DESIGN REVIEW BOARD

DESIGN REVIEW BOARD STAFF REPORT

Design Review Number:	20-02-DRB	Meeting Date:	March 11, 2020
Applicant:	David Weaver		
Property Address:	407 Avenue C		
Application Date:	February 10, 2020		
Project Description:	Demolish garage; build new garage/ADU and fence		
Land Use Designation:	Single Family	Requested Review:	<i>Detailed</i>
Compliance with Title 14:	No issues identified at this time

Southwest angle (Jerkinhead toward house)

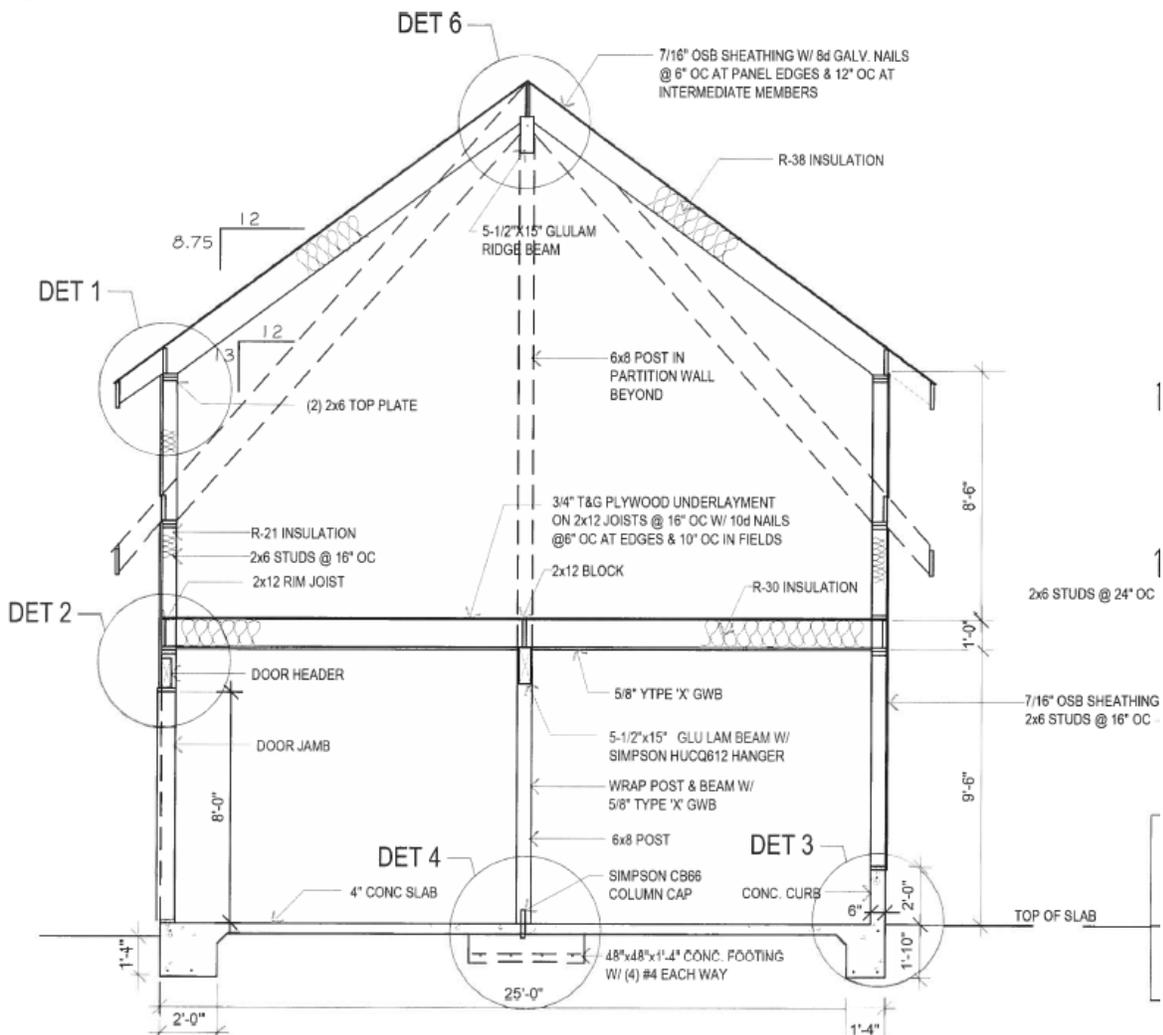
A 25-foot-by-30-foot detached garage with living area above is proposed in place of the old structure. A jerkinhead roof is proposed at a 8.75:12 slope, with gables facing the alley and the home. Mandors and windows are proposed on the gable façades, with two sets of garage doors facing the south. Windows are also proposed on the upper floor side elevations, beneath a shed-roof dormer projection.

The standards appear to be met. The proposed garage is located to the rear of the primary structure, and is subordinate in size and massing. The applicant states the height of the proposed structure will be a minimum of 8 inches below the main home. Proposed building materials appear to be consistent with the home.

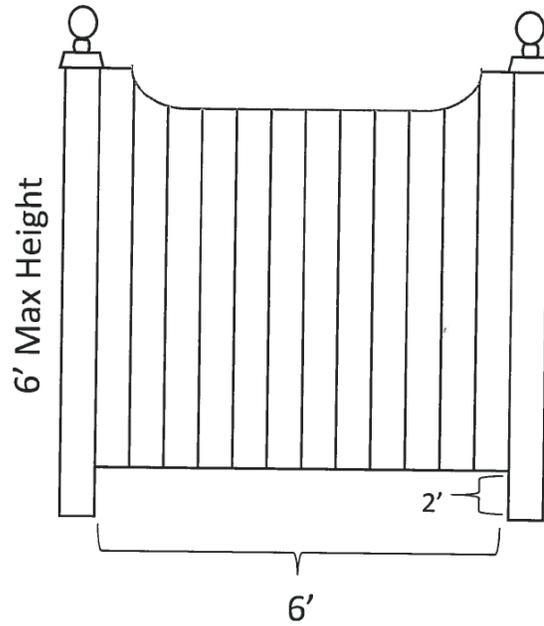
As proposed the fence will be no taller than six feet. A gate design was submitted but it is unclear where the gate is proposed.

Boards are vertical but are not capped. The Board may wish to discuss whether the curved design sufficiently modulates the top ends to meet the standard.

Railing information

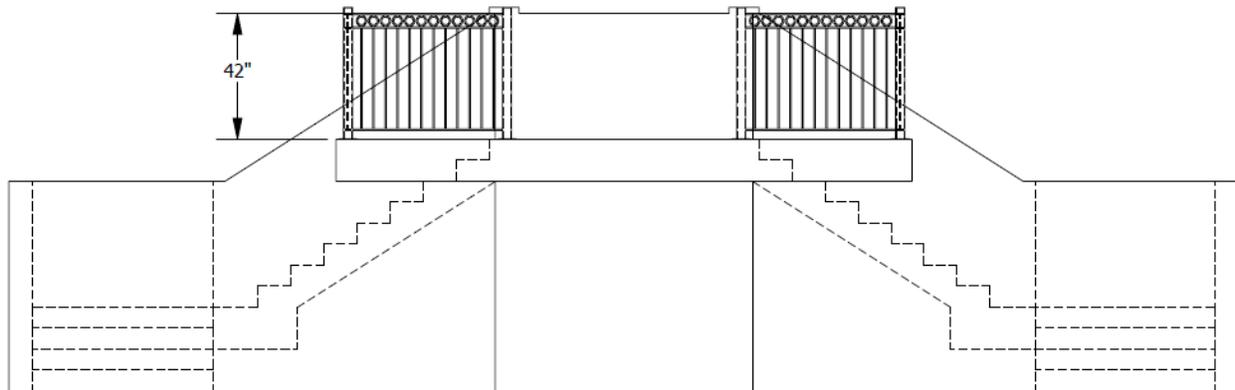
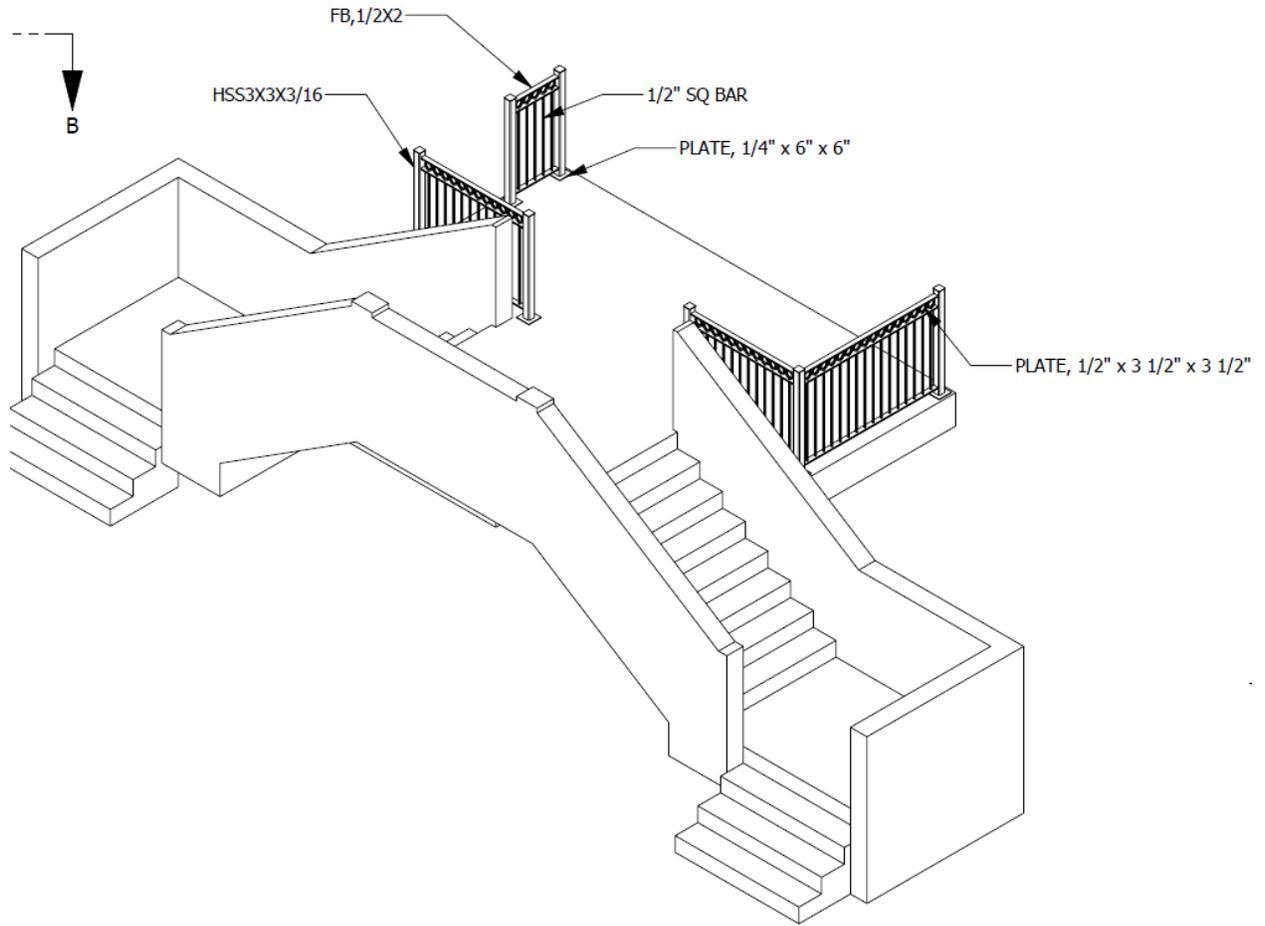
Railings are not industrial in design or appearance. The top element will be used for grasping.
